# MERCUISER SERVICE BULLETIN

Section: XII (Service  
Bulletins)  
Number: 13 64-05  
Date : 3/20/64

Figure 1. Fitting 90° Bend

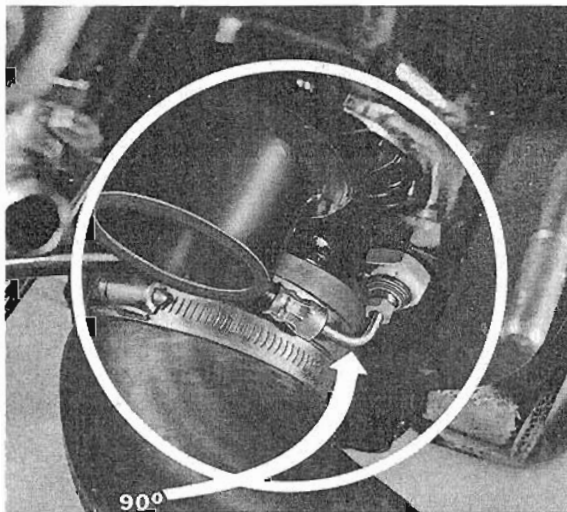
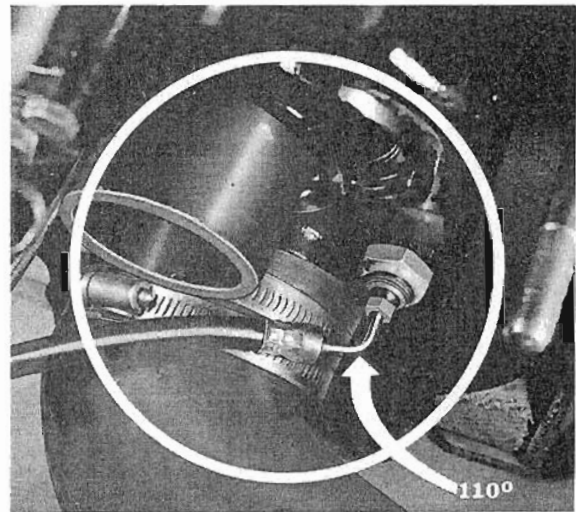
Check hydraulic hose connection on gimbal housing assembly BEFORE installing on boat or when servicing Power Tilt. If hydraulic hose connection has a 90° bend (Figure 1), open bend up 20°. (Figure 2) This will help eliminate the possibility of kinking the hydraulic hose and subsequent malfunction of hydraulic tilt system. If hydraulic hose is kinked or bent sharply, the drive unit may tilt up properly, but its return to operating position will be much slower than normal.

Figure 3. Matching Color Strips

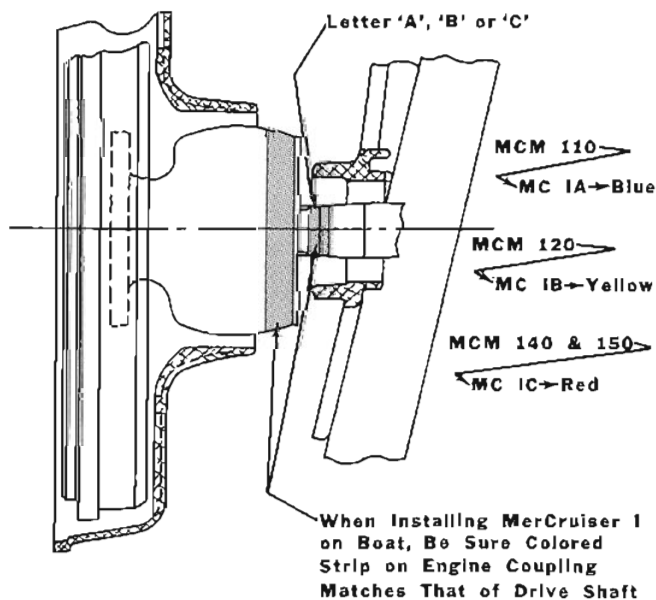
MerCruiser IA-IB-IC drive shafts and engine couplings are color coded to help prevent mismatching drive units and engines during installation. When installing MerCruiser IA-IB-IC drive units, be sure that the colored stripe on the engine coupling matches that on the drive shaft. (Figure 3)

If paint is removed from drive shaft, identification can be made by checking for letter "A", "B" or "C" stamped on end of universal shaft (Figure 3) or after serial number on drive shaft housing.

Figure 4. Securing Set Screw

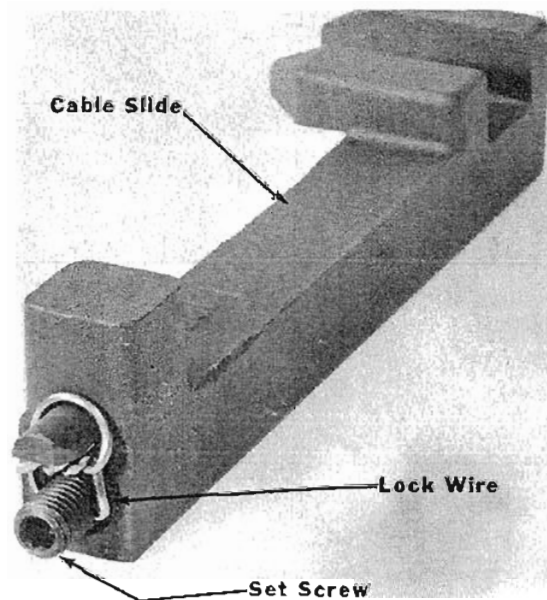
Tighten screw securely, then back off approximately 1/4-turn. The screw must be loose enough to permit cable to turn or rotate freely, but tight enough to minimize end play between cable and cable slide. Secure screw with lockwire. (Figure 4)

Figure 8. Center Line to  
Center Line 6-1/4" Dimension

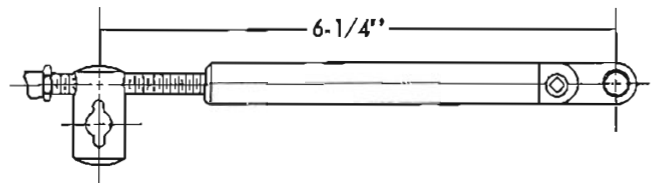
- b. With cable end guide installed and unit in full forward gear (full reverse gear engagement on left hand propeller rotation units), the distance from center line of brass barrel to center line of cable end guide mounting hole must be exactly 6-1/4". (Figure 8) Re-adjust brass barrel to achieve this dimension.

Figure 10.  
Inaccurate Gauging  
of Rough Points

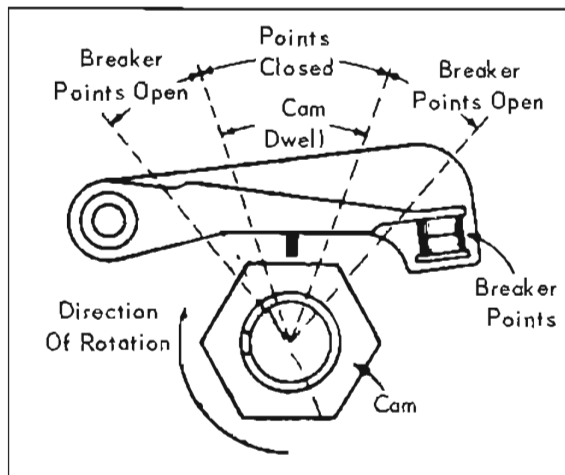
Mechanical gauging of breaker points is not as accurate as a dwell meter check because a mechanical gauge measures between high spots on points instead of true point opening. (Figures 9 & 10) For optimum performance, use Service Tachometer & Dwell Meter (91-31591) on all tuneups.
